**1958 Agreement – Consideration of proposals for new Regulations  
submitted by the Working Parties subsidiary to the World Forum**

### **Proposal for the 01 series of amendments to the new Regulation on frontal impact with focus on restraint systems**

#### **Submitted by the Working Party on Passive Safety \***

Model A

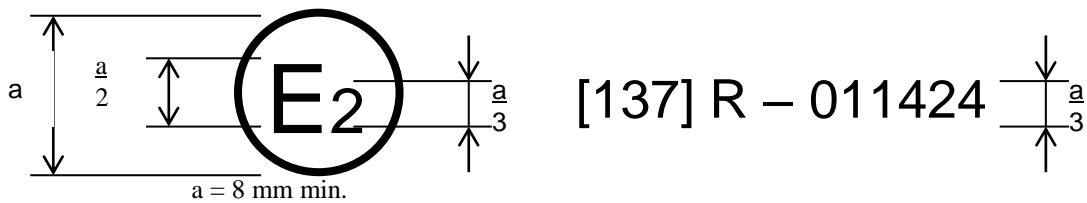
Annex 2, amend to read:

The above approval mark affixed to a vehicle shows that the vehicle type concerned has, with regard to the protection of the occupants in the event of a frontal collision, been approved in France (E 2) pursuant to Regulation No. [137] under approval number 011424. The approval number indicates that the approval was granted in accordance with the requirements of Regulation No. [137] 01 series of amendments.

Model B

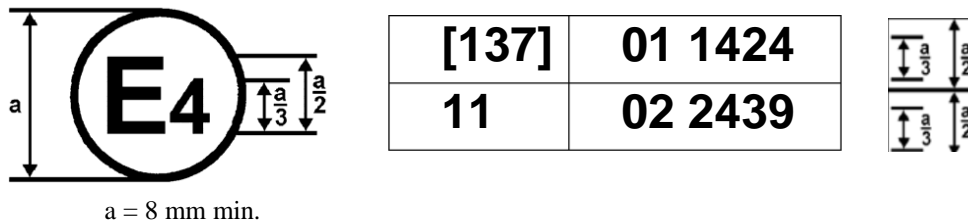
The above approval mark affixed to a vehicle shows that the vehicle type concerned has been approved in the Netherlands (E 4) pursuant to Regulations Nos. [137] and 11.<sup>1</sup> The first two digits of the approval numbers indicate that, at the dates when the respective approvals were granted, Regulation No. [137] incorporated the 01 series of amendments and Regulation No. 11 incorporated the 02 series of amendments."
